Transportation Tie-Down Best Practices

Service Category Suspension

Section Front Suspension

Applicability

Figure 1.

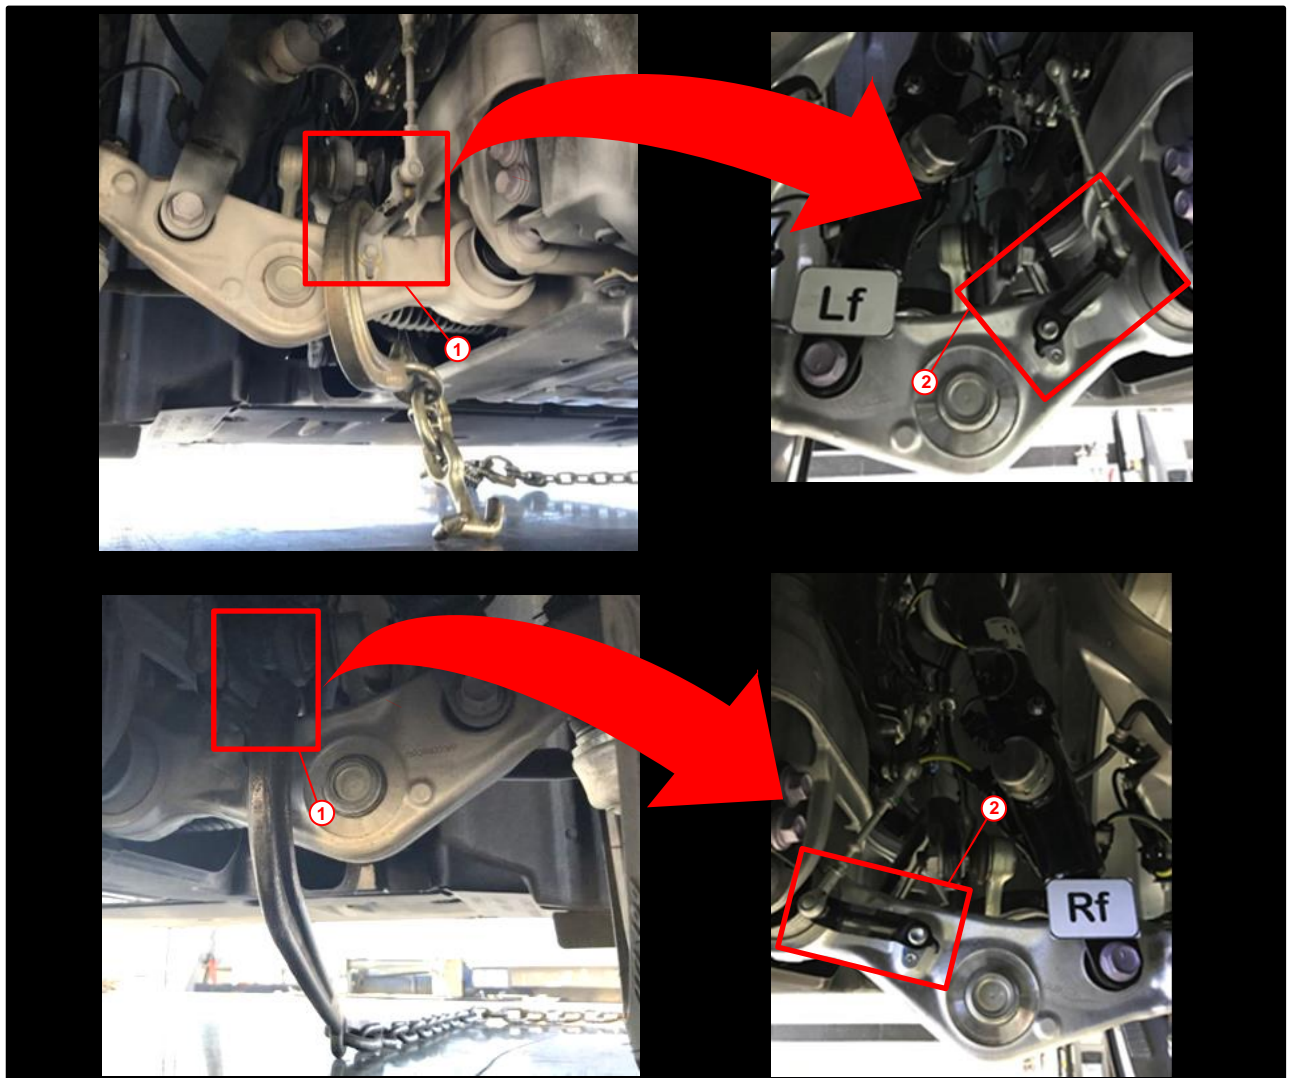
- If the vehicle is NOT towed correctly, the front height adjustment sensor bracket may be vulnerable to damage due to the layout of the front suspension.
- When shipping a vehicle, some third-party towing companies that use flatbed trucks do NOT follow the recommendations found in the Owner's Manual to secure the vehicle.
For example, some towing companies may secure the vehicle with metal hooks around the front lower control arms as a mount point. The front height adjustment sensor bracket is fixed to the lower control arm, and using this method risks bending the bracket if the strap or chain contacts this bracket under load.

Toyota Motor North America (TMNA) recommends that dealers ensure towing companies are aware of proper hook and tie-down points and the risks if not performed properly. Customers should be educated in situations when non-dealer roadside assistance is used. If the vehicle has a damaged front height adjustment sensor bracket after being towed by a third-party towing company, please advise the dealer service department immediately, as the towing company may be responsible for damages.

1. Refer to the applicable Owner's Manual for the vehicle hook location to load on a flatbed:
 - [2018 LC 500/LC 500h Owner's Manual](#)
 - [2018 LS 500 Owner's Manual](#)
 - [2018 LS 500h Owner's Manual](#)
2. If the procedure in the Owner's Manual CANNOT be performed, request for additional information and support when necessary to load the vehicle.

Do NOT use metal hooks on suspension components for recovery.
